RE: Traffic Assessment – 75 Station Lake Road Lara VIC 3212

This letter has been prepared to formally address the City of Greater Geelong's Development Engineering Unit's RFI items for access and parking at the proposed site, 75 Station Lake Road Lara:

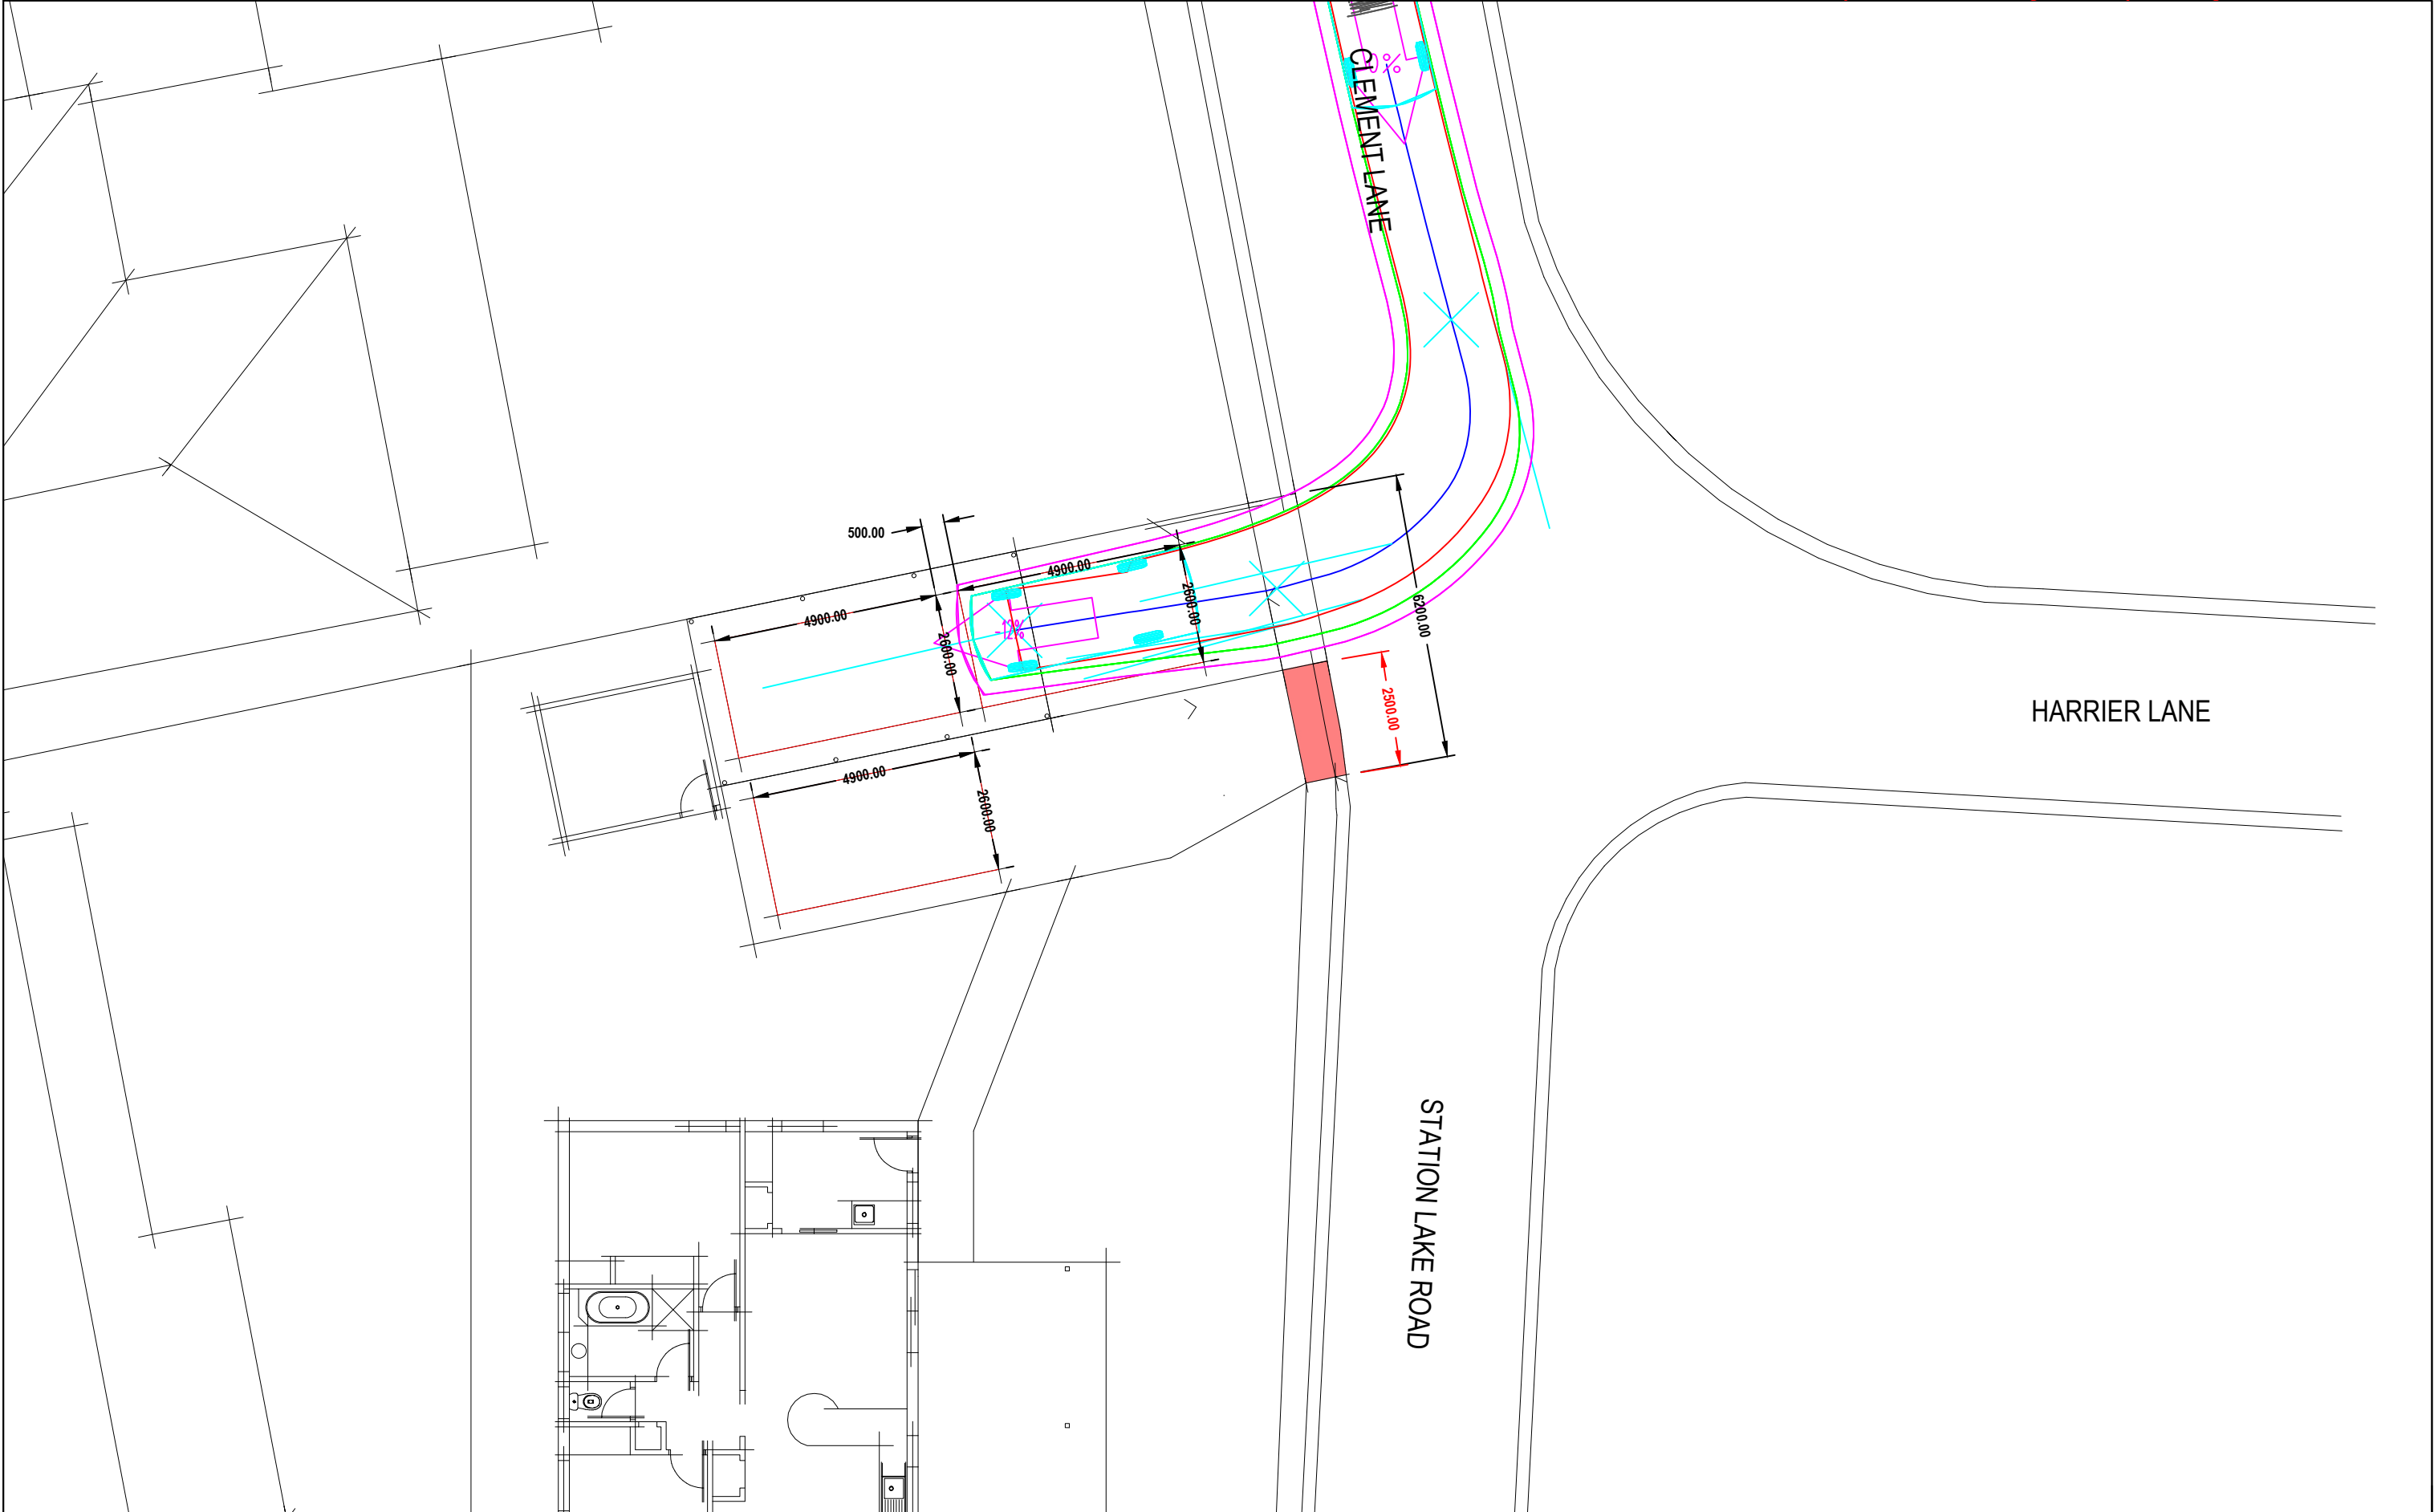
- *The vehicle crossing must be reduced to 4.0 m in width unless a wider crossing can be justified by swept path analysis demonstrating the operational need. Typical council requirements generally limit vehicle crossing widths within residential unless a larger width is supported by engineering evidence.....*
- *Whereby a crossover greater than 4m is proposed engineering evidence (swept path analysis) to support the wider width along with an amended car park design.*

- **Dwg 26.42-0001:** Space 1 Entry
- **Dwg 26.42-0002:** Space 2 Entry
- **Dwg 26.42-0003:** Space 3 Entry
- **Dwg 26.42-0004:** Space 1 Exit
- **Dwg 26.42-0005:** Space 2 Exit
- **Dwg 26.42-0006:** Space 3 Exit

- A B85 design vehicle can successfully and safely enter each proposed car parking space in accordance with AS2890.1:2004 and the Greater Geelong Planning Scheme.
